Code of practice for gas installation

AMENDMENT NO. 2

March 2020

Singapore Standard SS 608:2015+A1:2017
Amendment No. 2

4. Pages 38, Figure 9 Typical gas installation chased in solid wall

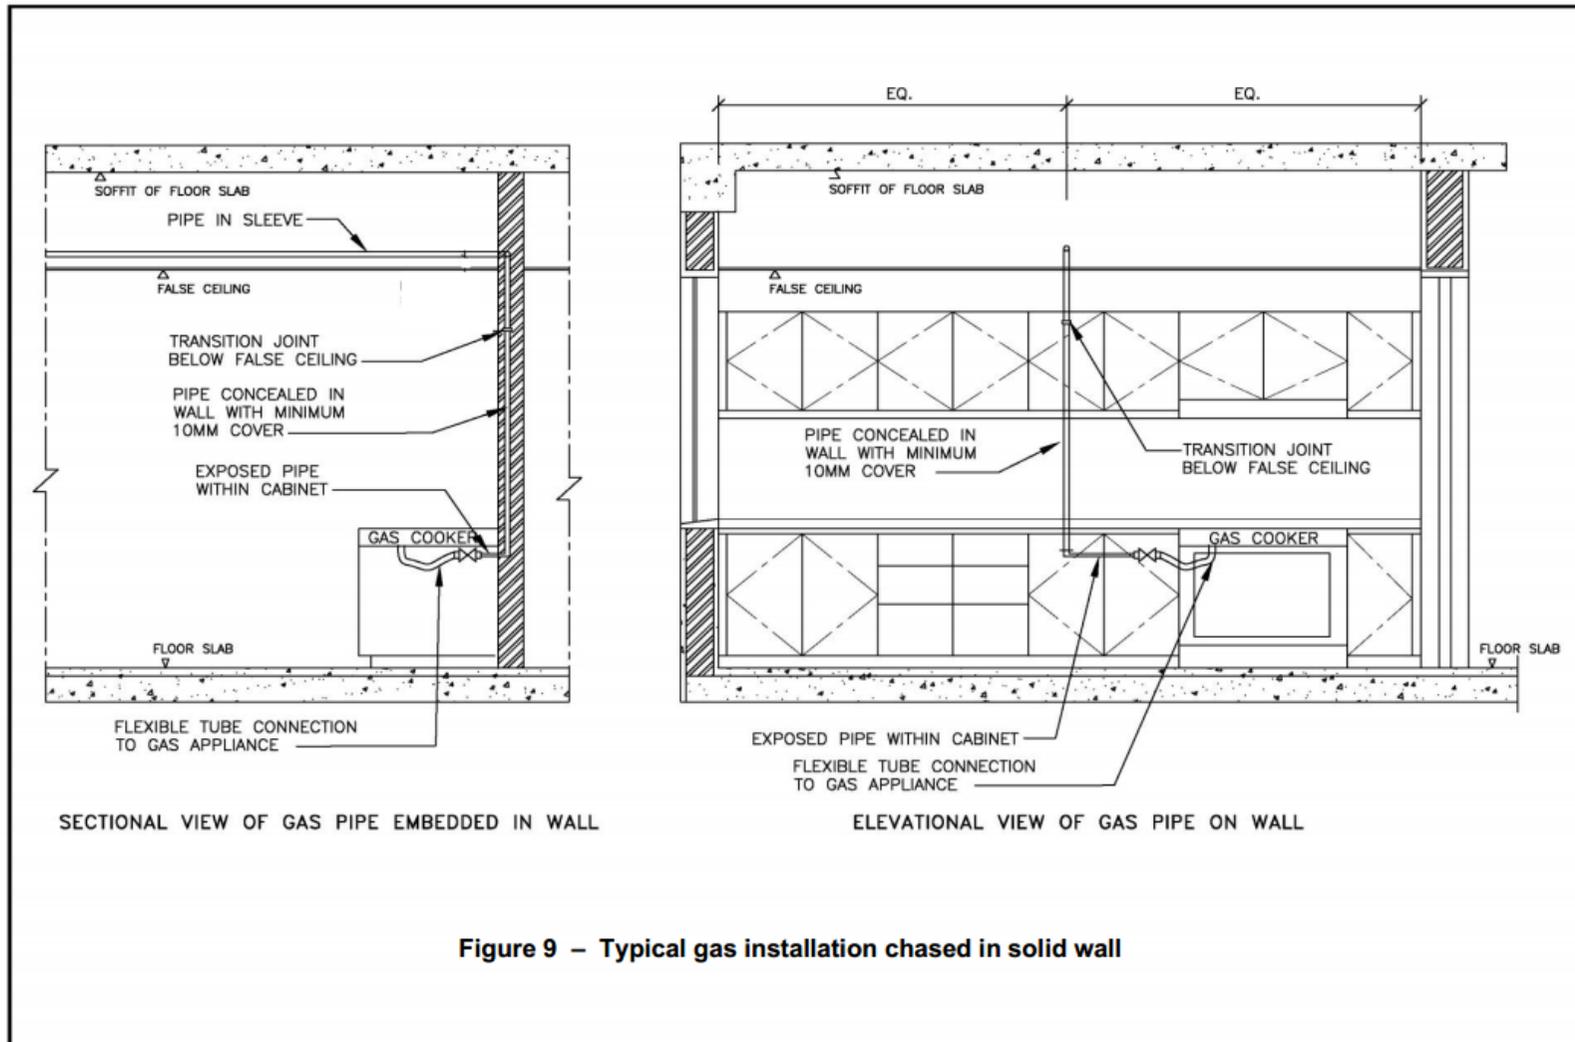
Replace Figure 9 with the new figure below.

Transition join, if required, shall be provided for jointing of pipes of dissimilar materials and shall be located below the false ceiling (Figure 9).

Figure 11 – Typical gas meter installations (residential)

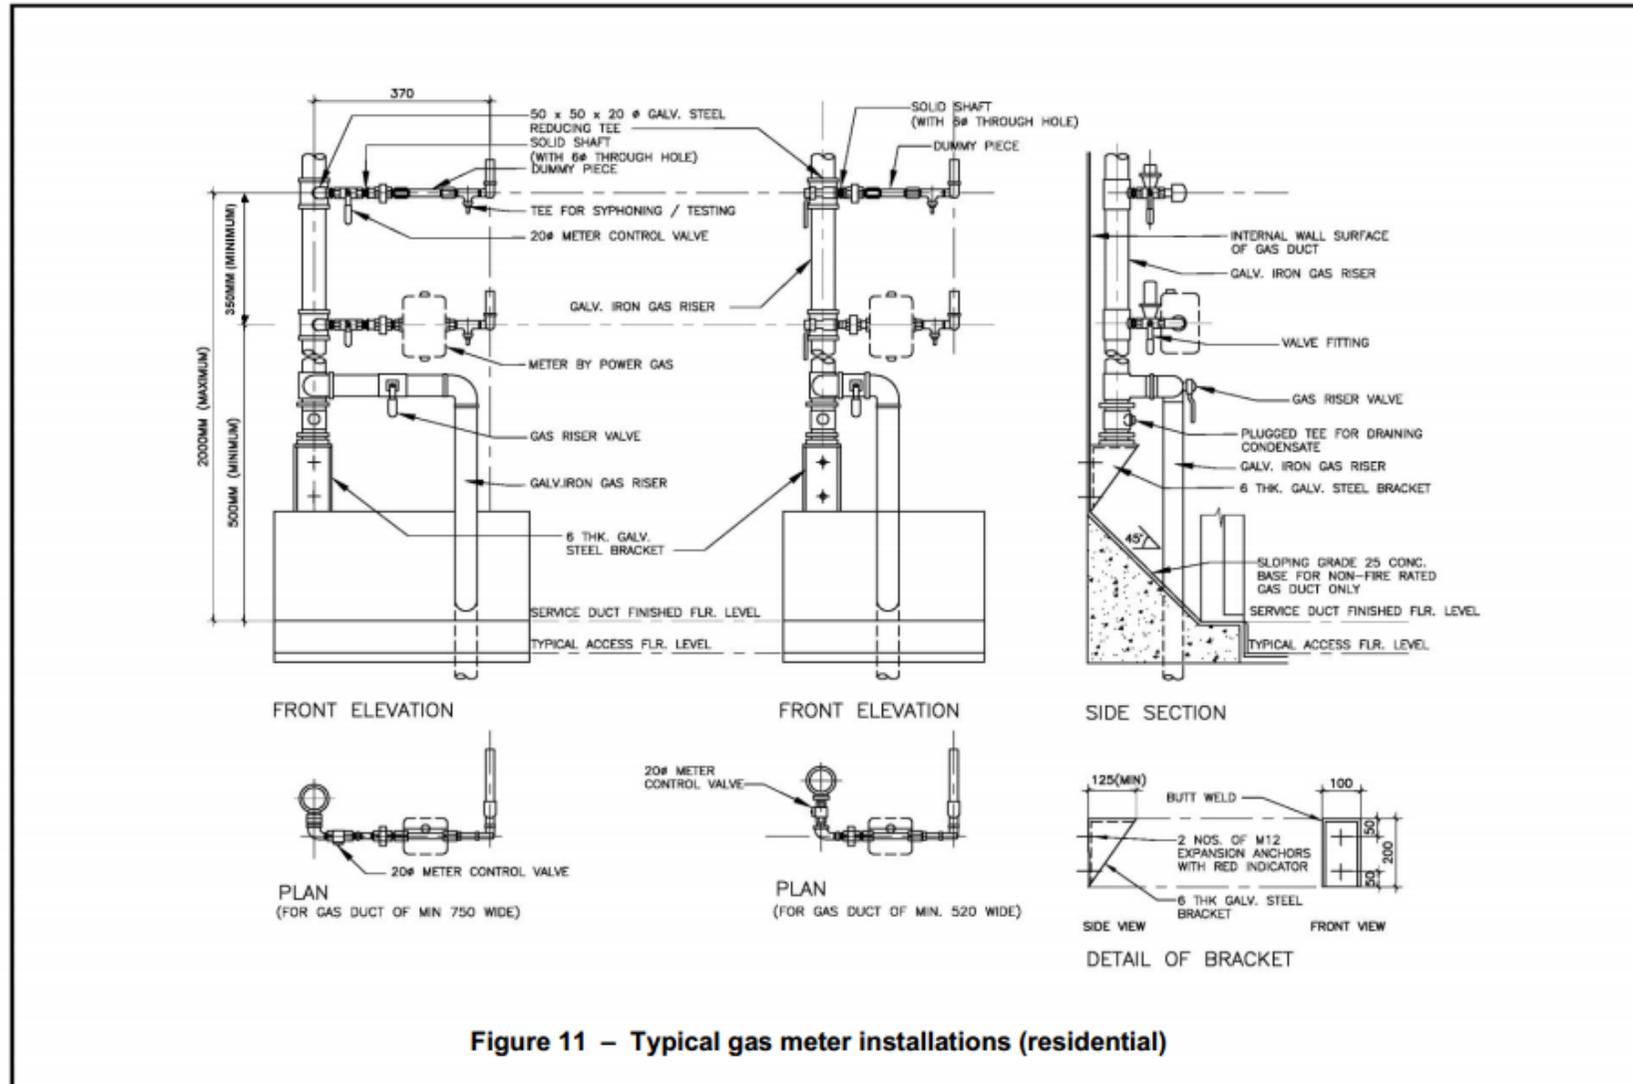
5. Page 40, Figure 11 Typical gas meter installations (residential)

Replace Figure 11 with the new figure below.
